March 20, 2018
15045

Third Party Review of the Rezoning Petition in Northern Aroostook County, Fish River Chain of Lakes Concept Plan

SLOPE EVALUATION OF FISH RIVER CHAIN OF LAKES DEVELOPMENT AREAS

Square Lake E Development Area
0-10% Slope = 137.568 Acres
10-20% Slope = 112.429 Acres
>20% Slope = 31.085 Acres
Total Area = 281.084 Acres

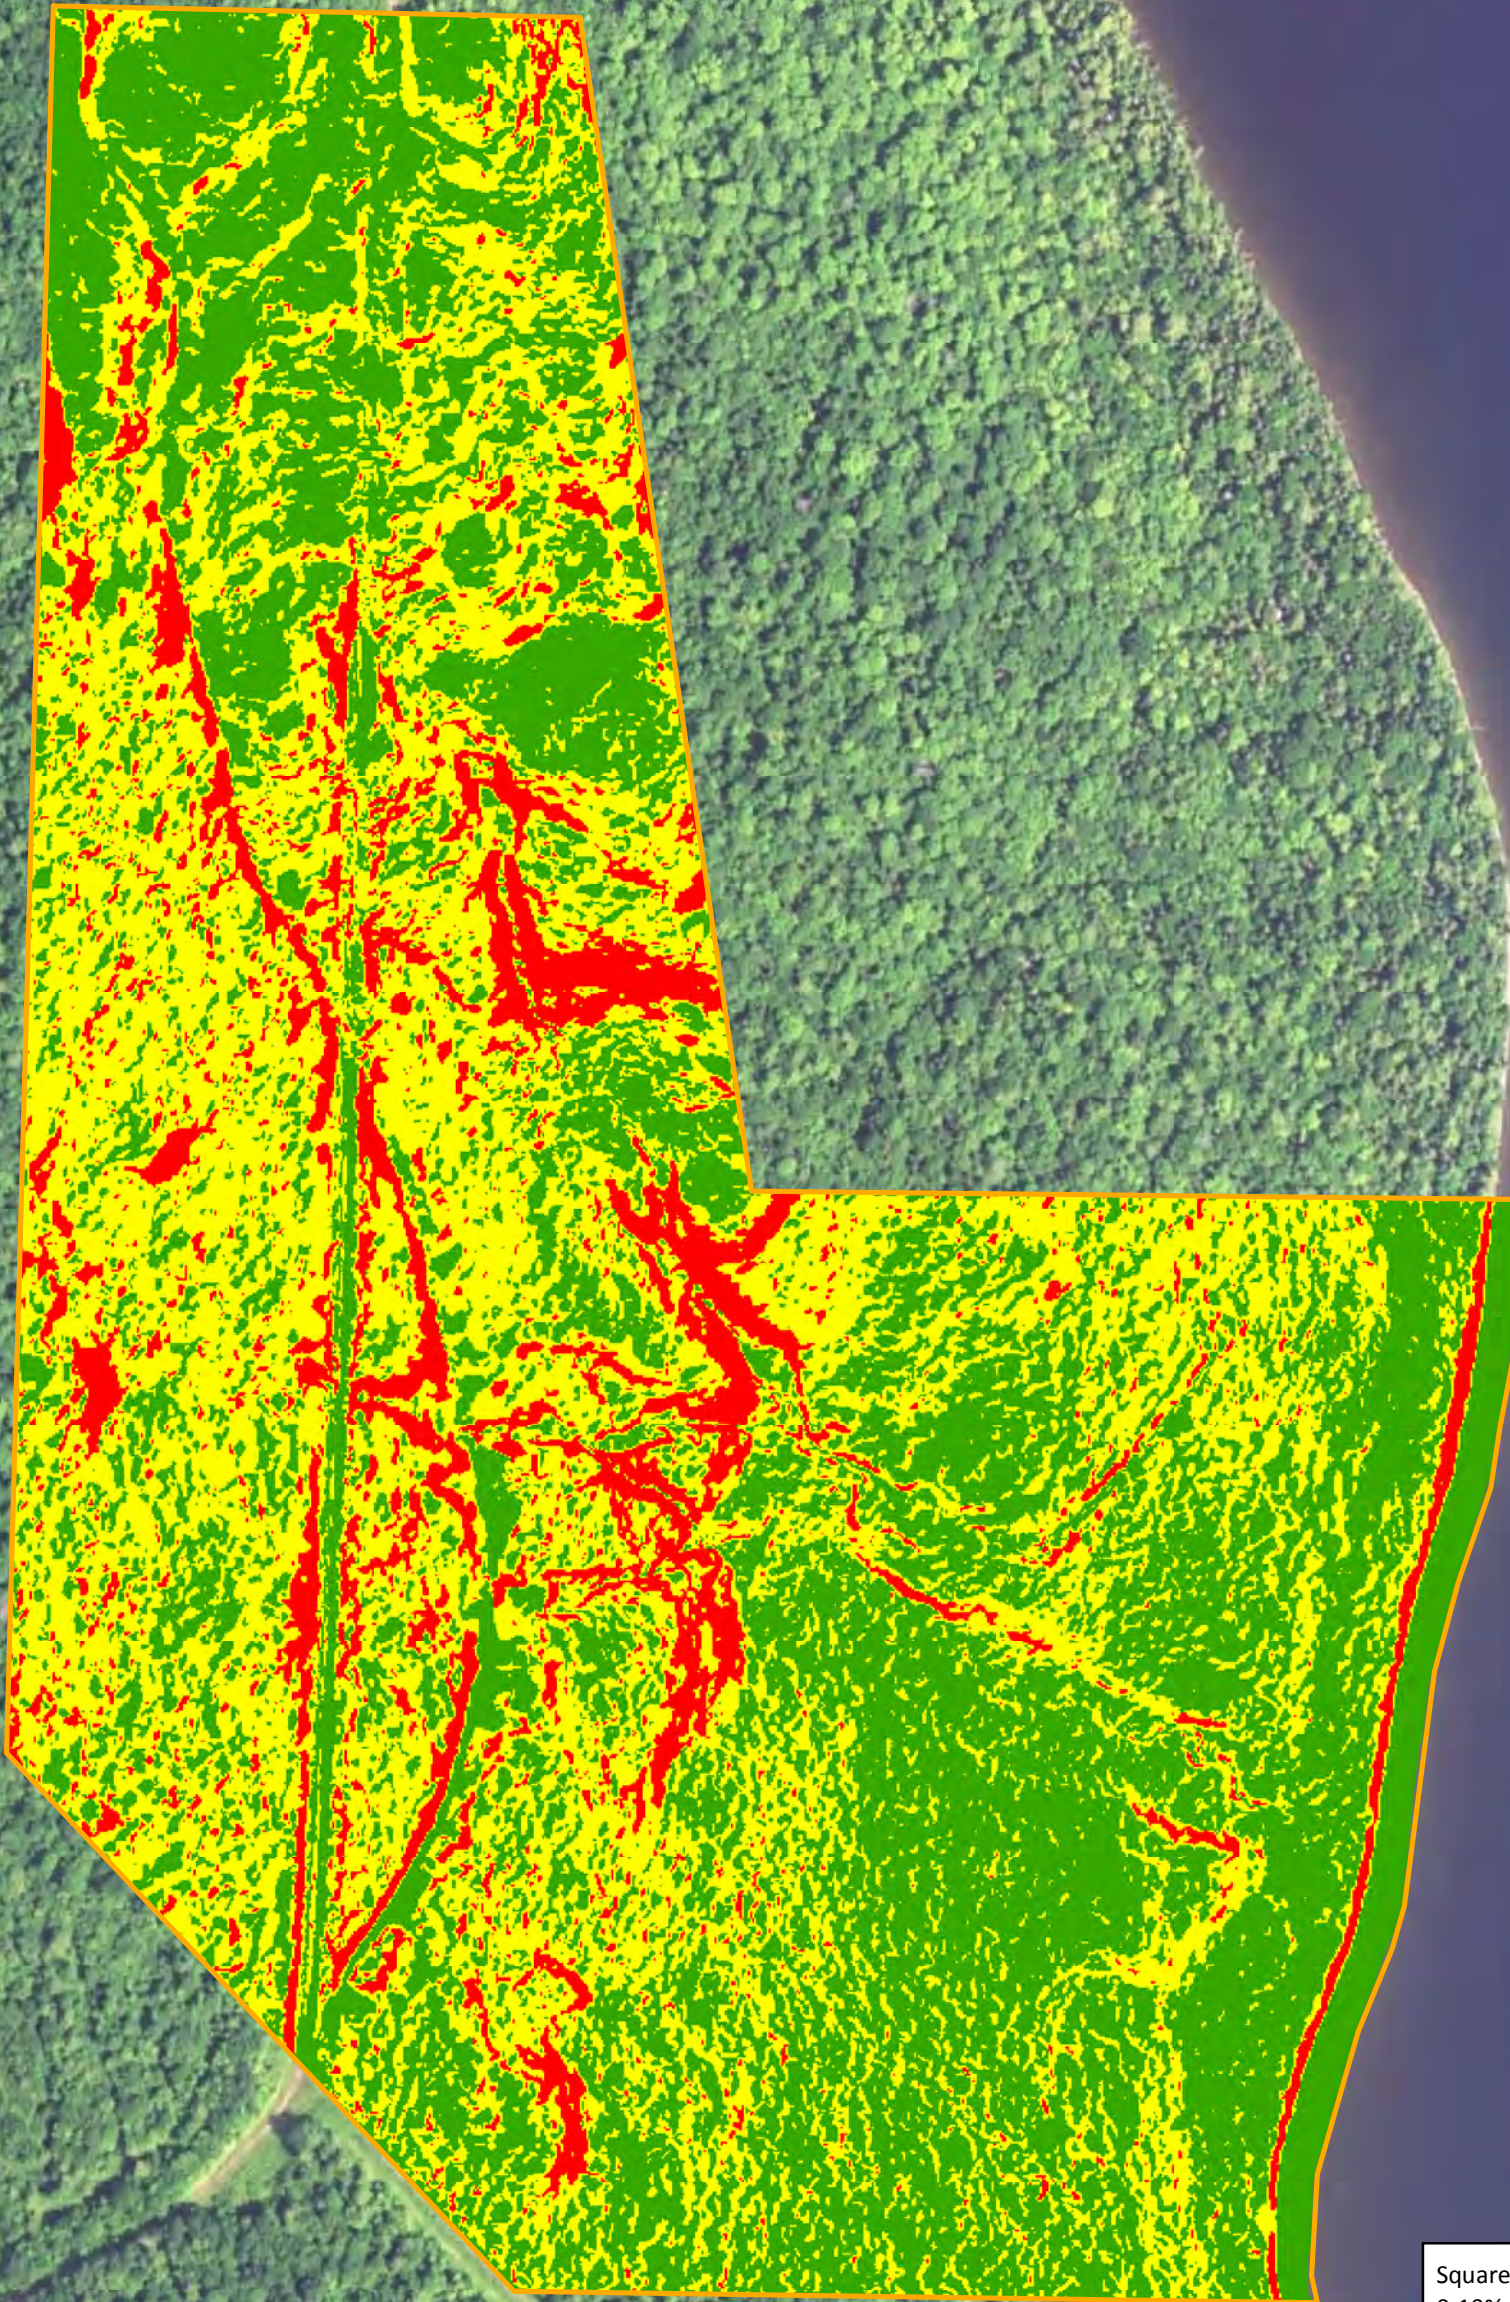
1. Slope Analysis: The slope analysis indicates approximately 31 acres of the development area contain slopes greater than 20 percent and generally considered unsuitable for development. The greater than 20% slopes are generally associated with linear features most likely contiguous slopes on hillsides. The area adjacent to Square Lake generally contains a shoreline section of slopes greater than 20% restricting the development in this area. Slopes 0-10% slopes encompass approximately 138 acres. Limited suitability slopes (10 to 20% slopes) encompass approximately 112 acres of the project area. The slope assessment suggests the development area is suitable for the intended purposes noting that the slopes greater than 20% are not considered suitable for development due to limitations for wastewater disposal systems, erosion and drainage control considerations and slope stability. Provided the development planning avoids the

steeper slopes and recognizes the partial limitations of the 10% -20% slopes, adequate land area exists to accommodate the 85-unit density.

2. The soils in this development area (NRCS Mapping) include PgC (Plaisted gravelly loam), HoC (Howland gravelly loam), PvC (Plasited Howland association), HcV (Howland silt-loam) soil series. These soils range from a gravelly loam to a silt-loam and are moderately well drained to well drained soils with a water table over 16 inches and considered a hydrologic group "C" and "C/D" soils. These soil types do not suggest impractical limitations for development beyond localized limitations as a result of steep slopes (over 20%) and a higher-grade soil mapping. We would note that the HcV soils are considered a finer soil and may be more susceptible to erosion when disturbed but are generally suitable for development. Wetlands areas were also identified on the project site and generally located along the Square Lake Yexas and Square Lake E property division line and near the southerly end of the Square Lake E development area. The Wetlands are considered not suitable for development.

Considering the soils, streams, wetlands and associated development limitations, slopes over 20% and the development setback restrictions along the shoreline of Square Lake, our assessment suggests that the project area and number of planned units (85) yields an effective net density of 2.2 acres/unit. This represents a reasonable and appropriate net development density (Please refer to the development matrix analysis appended to this report). This assessment includes deductions for slopes over 20% and allowing for 25% of the 10% to 20% (limited suitability slopes) to be considered not suitable.

SQUARE LAKE W

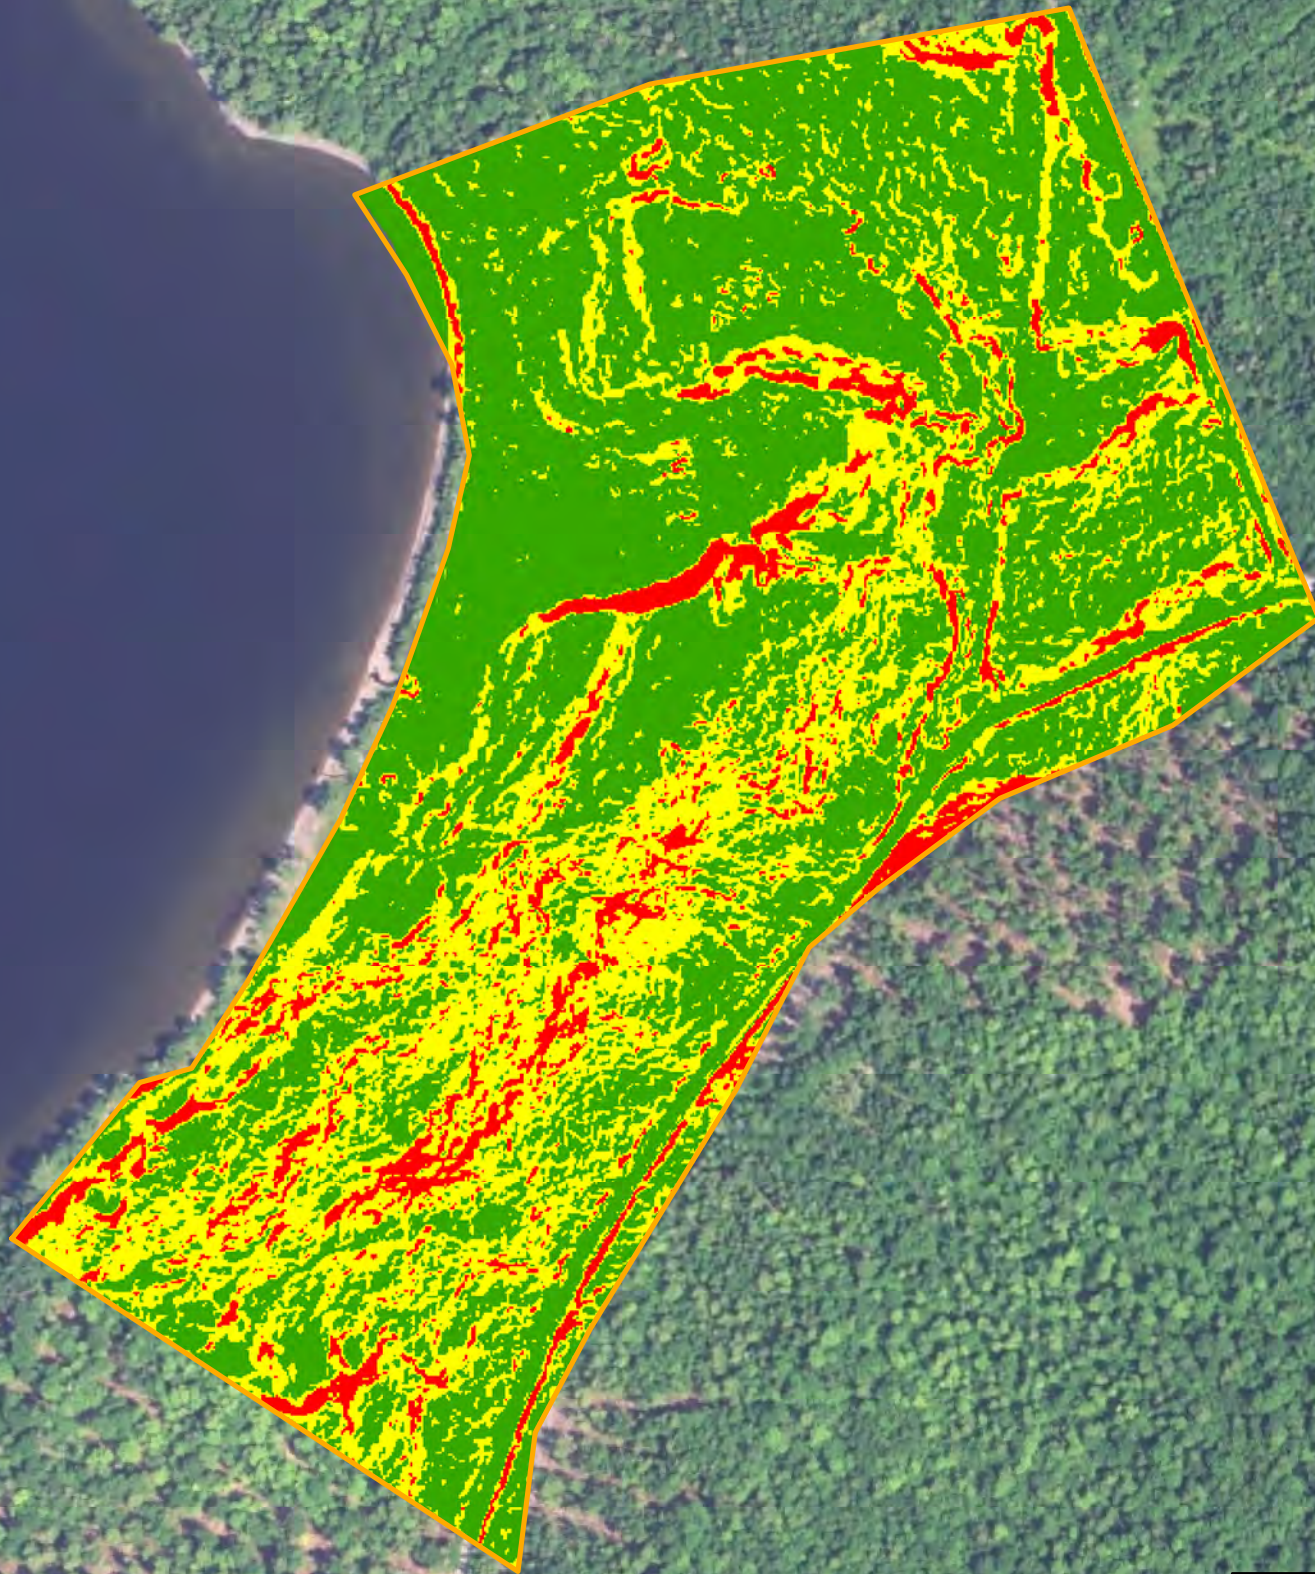
1. Slope Analysis: The slope analysis indicates approximately 13 acres of the development area contains slopes greater than 20 percent that are considered unsuitable for development. The greater than 20% slopes are generally scattered throughout the westerly area of the development parcel with some continuous linear slope features. The area adjacent to Square Lake generally contains 0-10% slopes interspersed with limited development areas of 10 to 20% slopes. The slope assessments suggest the development area is suitable for the intended purposes noting that the few areas of slopes greater than 20% which are not considered suitable for development due to limitations for wastewater disposal systems, erosion and drainage control considerations and slope stability. Provided the areas of 20% slope features are avoided, the slope conditions are expected to be suitable for the intended use.

2. The soils in this development area (NRCS Mapping) include PvC (Plaisted Howland), HvB (Howland) and ThD (Thorndike channery silt loam) soil series. The ThD soils are considered unsuitable due to steep slopes, shallow to bedrock and expected susceptibility to erosion when disturbed. We would note that the soils mapping and the LIDAR data depict differences in the steep slope areas since the NRCS data is not based upon the more accurate LiDAR Data. As a result, we anticipate the areas of unsuitable soils due to steep grades will be dispersed throughout the development area as shown on the enclosed LiDAR mapping which consumes approximately 13 acres of the development area. Any development activities within the project area will need to be based upon actual field mapping of the slopes and soils to accurately integrate the physical slope restrictions in to the development. The PvC and HvB soils are both generally stony soils and located on slopes 8% to 15%. These soils are generally well drained with a water table over 2 feet and considered a hydrologic group "C/D" soil.

Considering the soil classifications, slopes and limitations for development along the shoreline of Square Lake, our assessment suggests that the project area and number of planned units (30) yields an effective net density of 2.7 acres/unit suggesting the proposed density and development area is reasonable and appropriate (*Please refer to the development matrix analysis appended to this report*). This assessment includes deductions for slopes over 20% and allowing for 25% of the 10% to 20% (limited suitability slopes) to be considered not suitable.
